Preliminary responses to OEH and SEWPaC comments on the Preferred Project
Report and Response to Submissions — biodiversity (26 March 2013)

Re: Cobbora Coal Project – Preliminary Responses to OEH and SEWPaC Comments on the Preferred Project Report and Response to Submissions – Biodiversity

DATE: 19/3/2013
MEMO TO: Department of Planning and Infrastructure – Stephen O’Donoghue
FROM: Gavin Heydon
SUBJECT: CLARIFICATION OF TAILINGS INFORMATION
REFERENCE:

The purpose of this addendum is to correct the results presented in Appendix E that were affected by a water balance model error, and to discuss the wider implications of the error for the Surface Water Assessment and Environmental Assessment. In addition, further information is provided in the addendum on additional model sensitivity analyses undertaken to address a concern of the DP&I's reviewer regarding the reliance of the mine on the surface water entitlement from the Cudgong river source. Specifically, the reviewer raised the concern that the volume of groundwater inflow to the mine pits available for use in the mine water management system may have been overestimated.

Figure 2.1 Annual imported water requirement over the 111-year water balance simulation for Year 20 (Figure 6.1 in Appendix E)

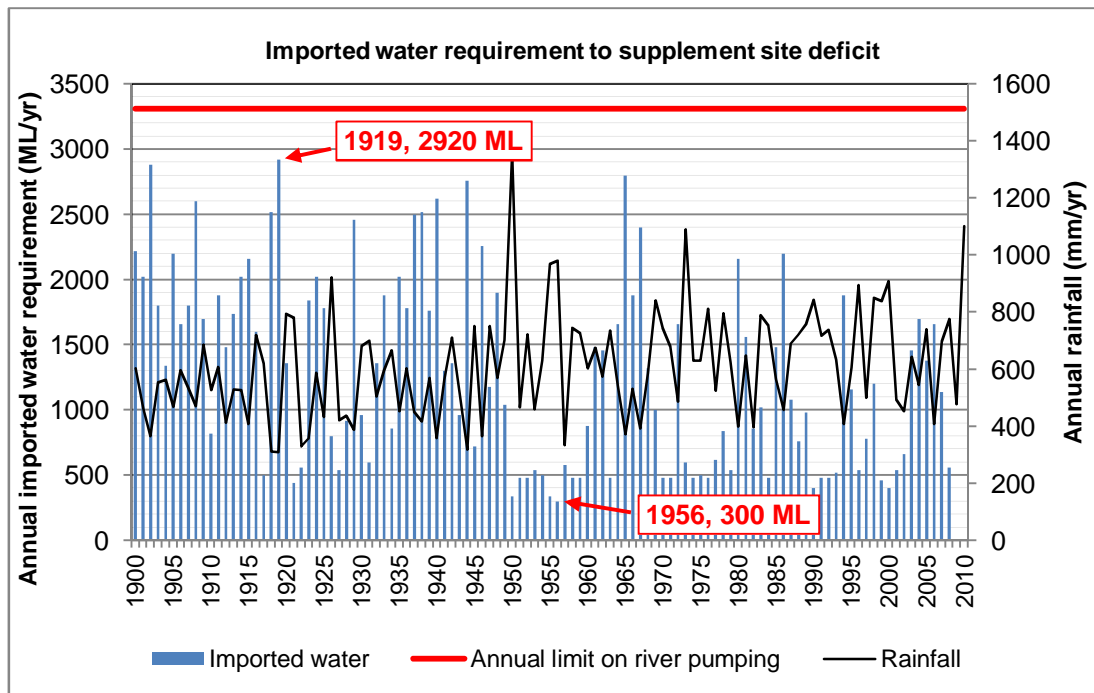
The corrected Figure 6.1 from Appendix E (Figure 2.1) presents the sequence of the simulated annual requirement for imported water for Year 20. The corrected figure shows that the peak requirement for imported water is 2,920 ML for the driest year on record of 1919, which is 391 ML below the Cudgegong entitlement, and the minimum peak requirement is 300 ML for the climate of 1956.

Figure 2.2 Results of sensitivity analysis of river water restrictions for peak imported water requirement year 20 (Figure 6.2 in Appendix E)

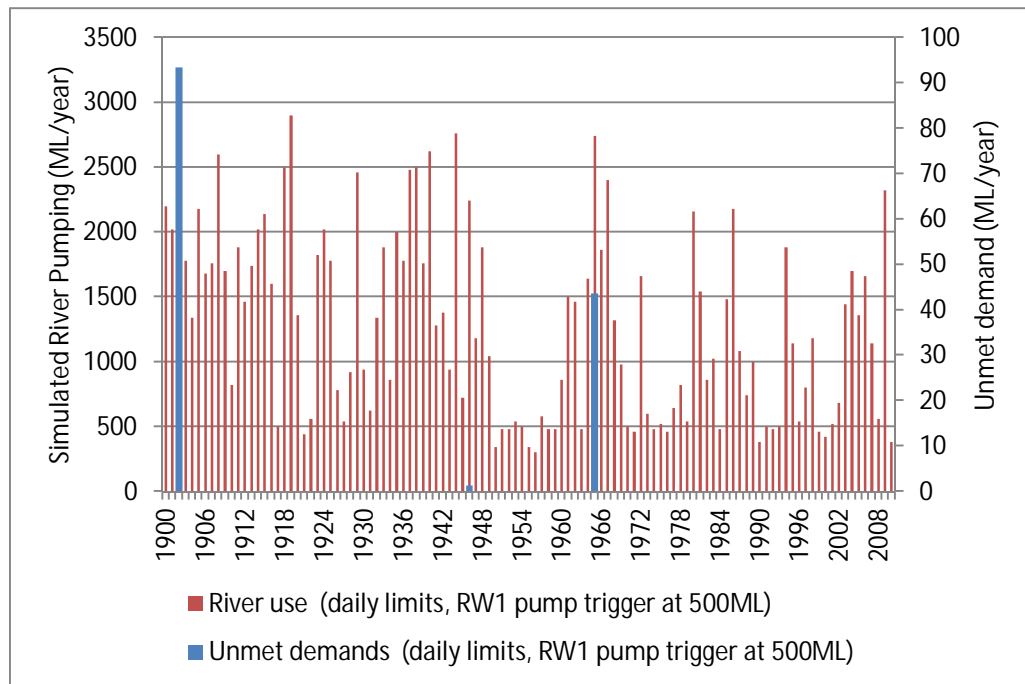
The sensitivity analysis involved running the synthetic streamflow sequence for Year 20 when imported water requirements are highest to determine the risk of a water deficit occurring at the peak water requirement year. The results of the sensitivity test are provided below in the corrected Figure 6.2 from Appendix E (Figure 2.2).

The corrected results show that there is a probability of a water deficit of 2% for the peak water requirement at Year 20, i.e. a deficit is predicted for a total of 2 years out of the 111 year sequence. The deficit ranges from 45 to 90 ML. The probability and peak magnitude of the deficit are considerably lower than the incorrect results of 21% and 334 ML as reported in Appendix E.

Figure 2.3 Simulated dam storage and overflows for SD10 for mining year 16 (Figure 6.3 in Appendix E)

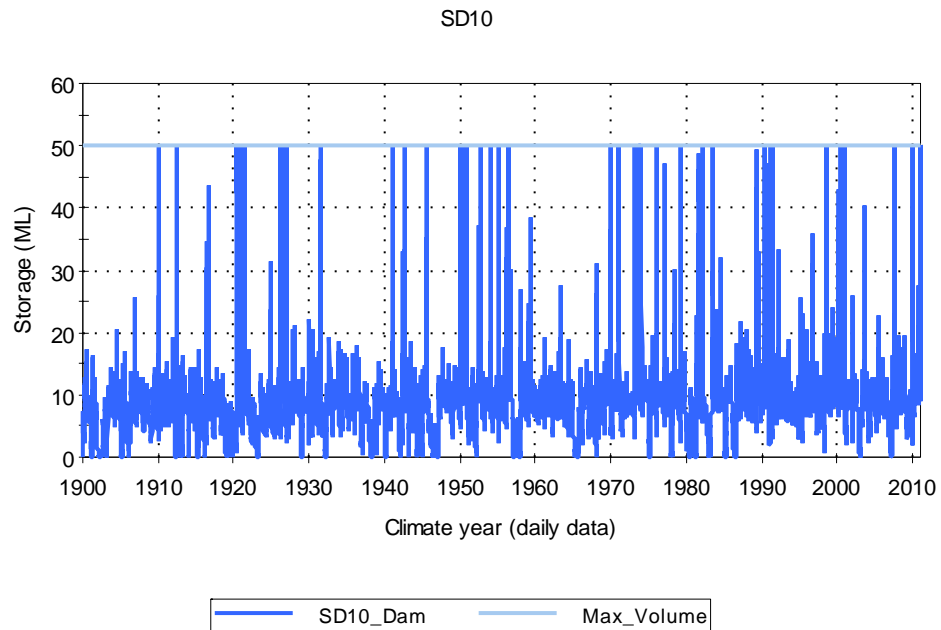
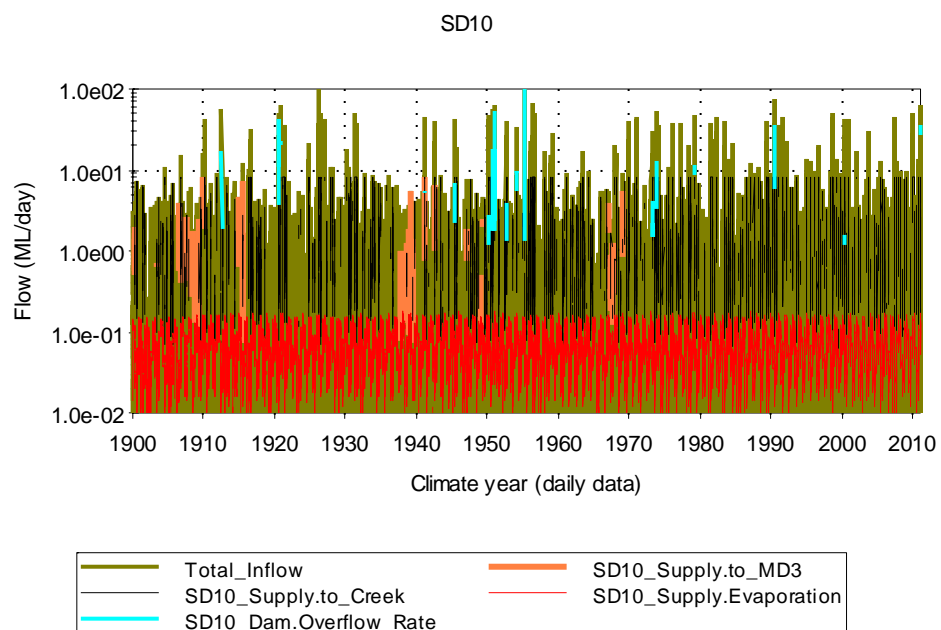
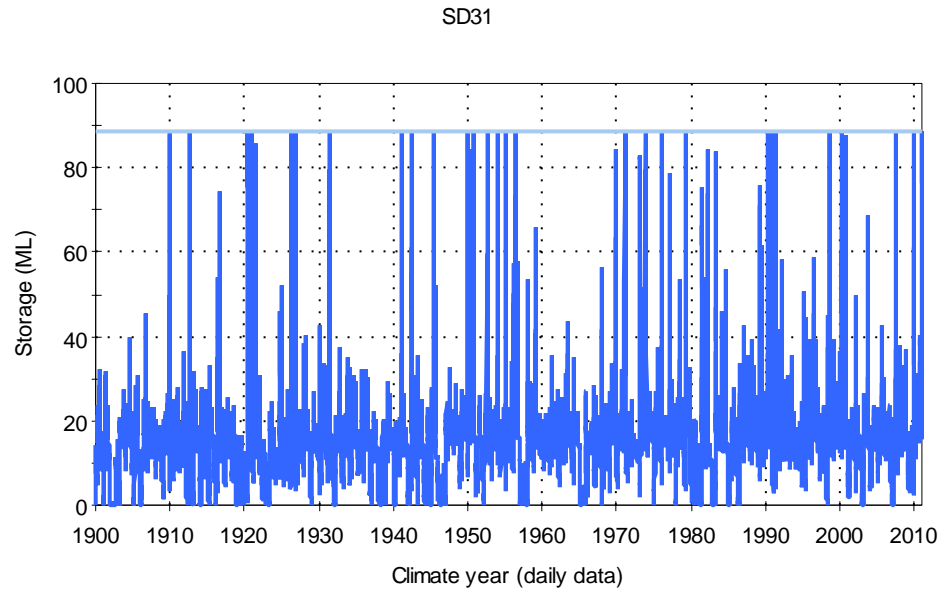
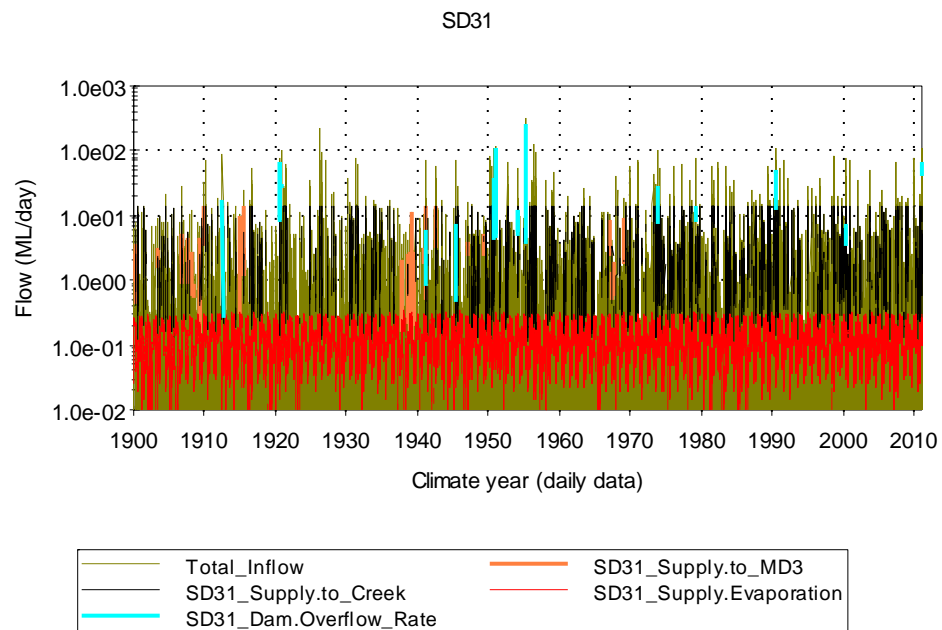
Section 6.1.2 of Appendix E presented a sample of results from the water balance model to demonstrate the performance of the sedimentation dams. This involved presentation of sample outputs for sedimentation dams SD10 and SD31. The corrected outputs are provided below in the corrected Figures 6.3 to 6.6 from Appendix E (Figures 2.3 to 2.6).

Additional information has been added to Figures 6.4 and 6.6 (Figures 2.4 and 2.6) to demonstrate the full water balance of the dams, which now include evaporation and the breakdown of controlled and uncontrolled releases to the local creeks.

Figure 2.7 Stored volume in mining area A over the 111-year water balance simulation for Year 16 (Figure 6.7 in Appendix E)

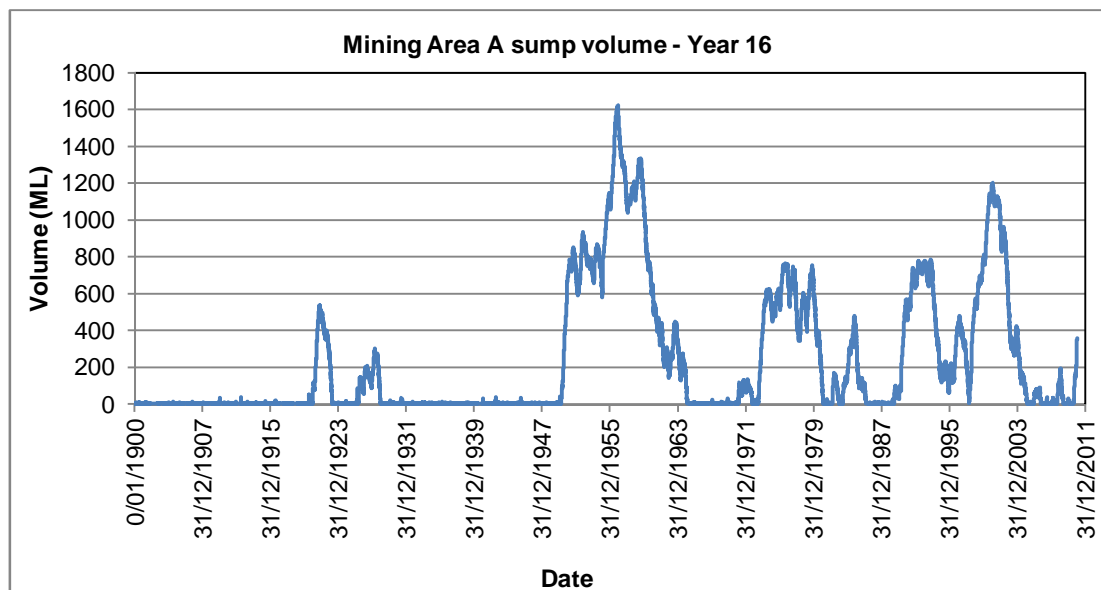
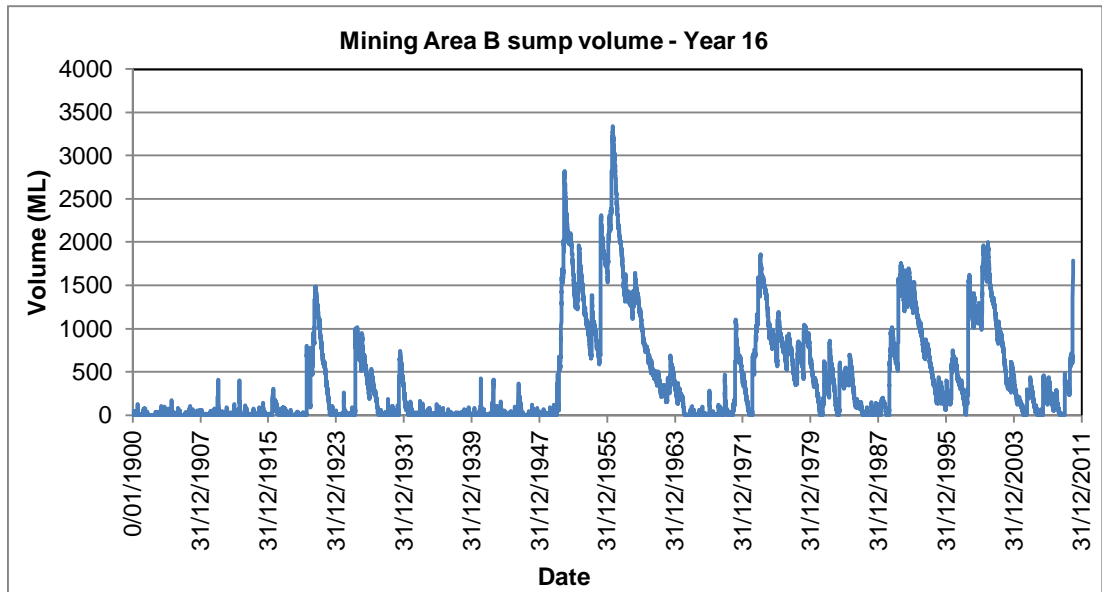
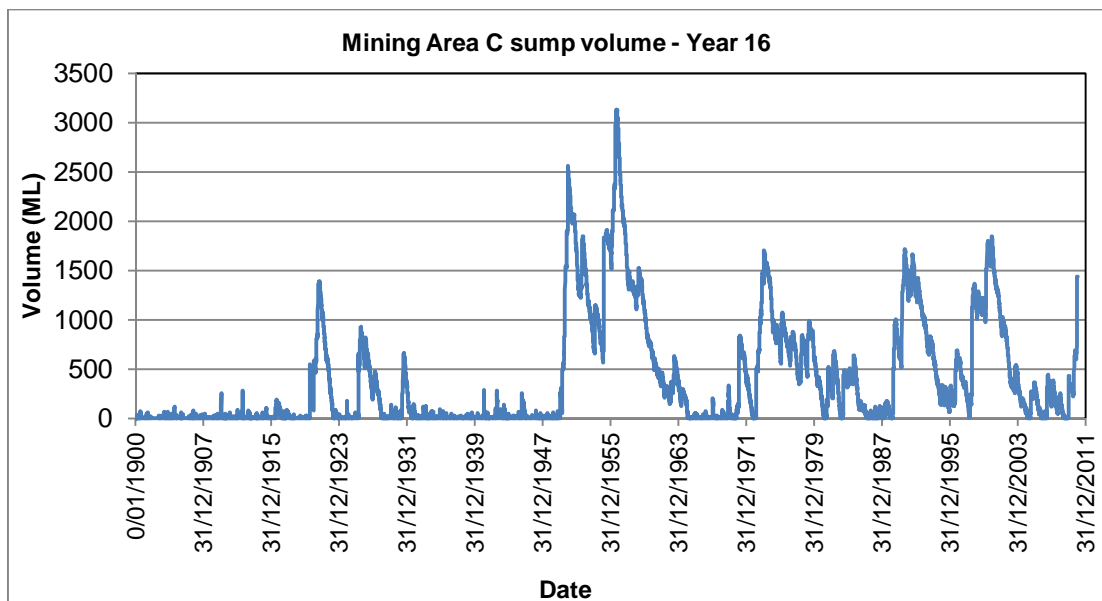
Predicted stored volumes per mining area over the 111-year water balance simulation are provided in the corrected Figures 6.7 to 6.9 below (Figures 2.7 to 2.9) for Year 16, when the mining area catchment is greatest and the estimated maximum volume stored in the combined pits is greatest. Predicted frequencies of in-pit flooding per mining area over the 111-year water balance simulation for Year 16 are provide in the corrected Figures 6.10 to 6.12 below (Figures 2.10 to 2.12). It should be noted that the results are shown for the worst case mine stage Year 16 when the combined in-pit storage in all three mining areas is highest. This also coincides with the worst case year for mining areas B and C but not A, which experiences maximum storage at Year 12 (see Table 2-7).

Figure 2.14 Worst case pit flooding for mining area A (Year 12) (Figure 6.14 in Appendix E)

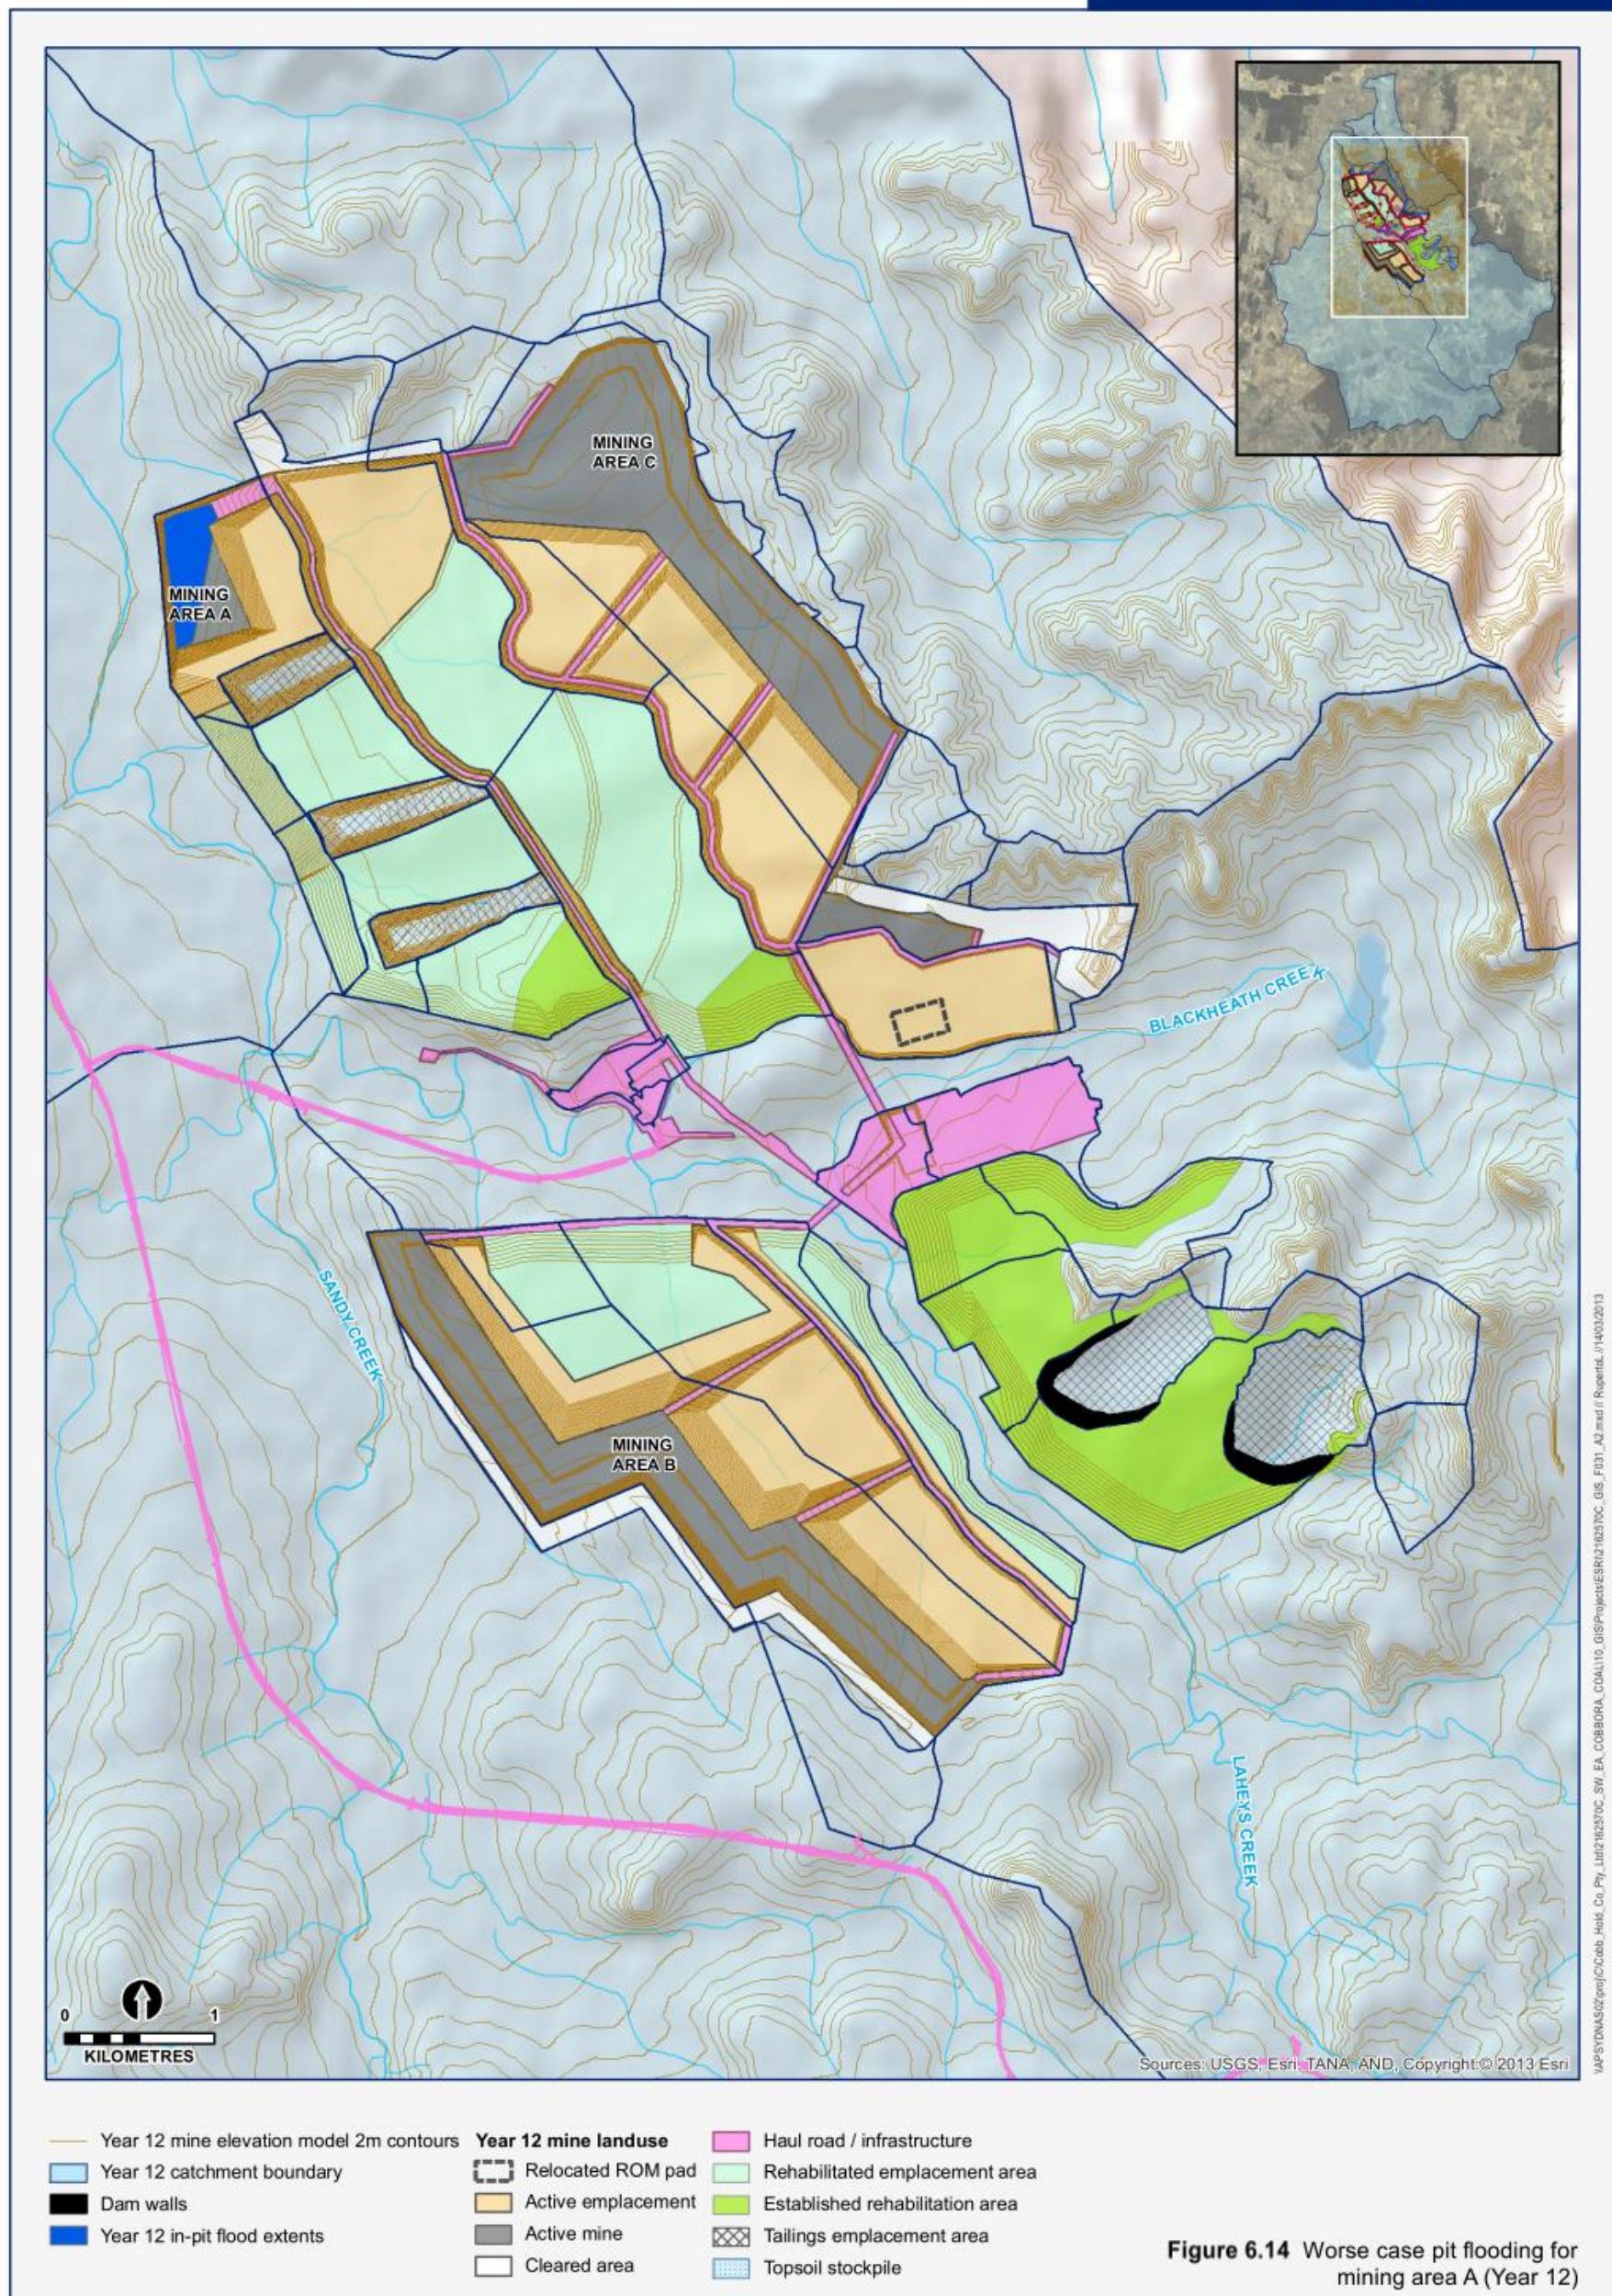
The worst case flood extents within each mining area are shown in the corrected Figures 6.13 and 6.14 below (Figures 2.13 and 2.14). The corrected figures show that under the worst case scenario mining operations can continue in pits B and C with multiple ramp access options. Peak flooding in pit A would inundate most of the pit, which would prevent operations in this area. The operation of concurrent mining areas will allow the continuation of mining in pits B and C under the worst case flooding scenario in pit A, with operations in pit A suspended until the pit could be dewatered.

Figure 2.15 Comparison of annual imported water requirements over the 111-year water balance simulation for Year 20 (Figure 7.1 in Appendix E)

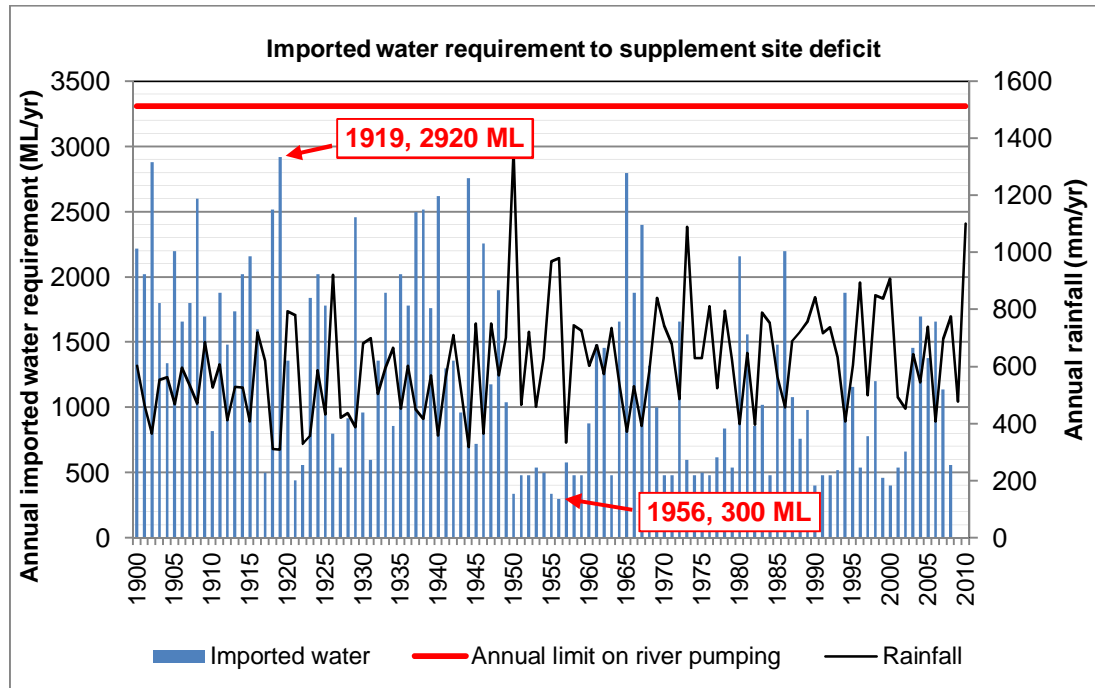
The corrected Figure 7.1 below (Figure 2.15) shows the imported water requirements over the 111 year simulation of the water balance model. The corrected figure shows that the peak requirement for imported water is 2,920 ML for the driest year on record of 1919, which is 391 ML below the Cudjegong entitlement, and the minimum peak requirement is 300 ML for the climate of 1956.
